June 24, 2021

Product Change Notice - Hinge and seal for AquaShed baggage doors

AquaShed series with 07 series-style hinge and new seal.

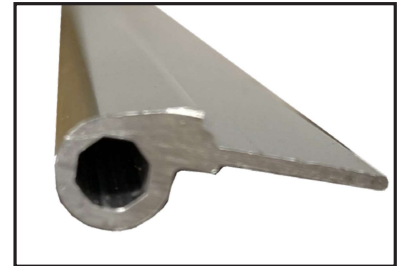
Please be advised, to alleviate a material shortage, Lippert intends to substitute the hinge and seal on AquaShed baggage doors.

The 07 series solid hinge PN 343069 will be substituted for the door's current solid hinge. The new hinge is nearly identical to the AquaShed hinge. PN 343069 is slightly more narrow, which fits the inner frame of the Aqua Shed.

Lippert also intends to change the door seal from a clip seal to PN 320743, which is a ribbed web seal.

**New seal
PN 320743**

**New hinge
PN 343069**

Both substitutions have been tested and approved by Lippert as equal to the current seal and hinge.

There is no change in fit, function or installation of the baggage door with the new hinge or seal. There is no part number change for the door and no price change. The change is expected to start late July.
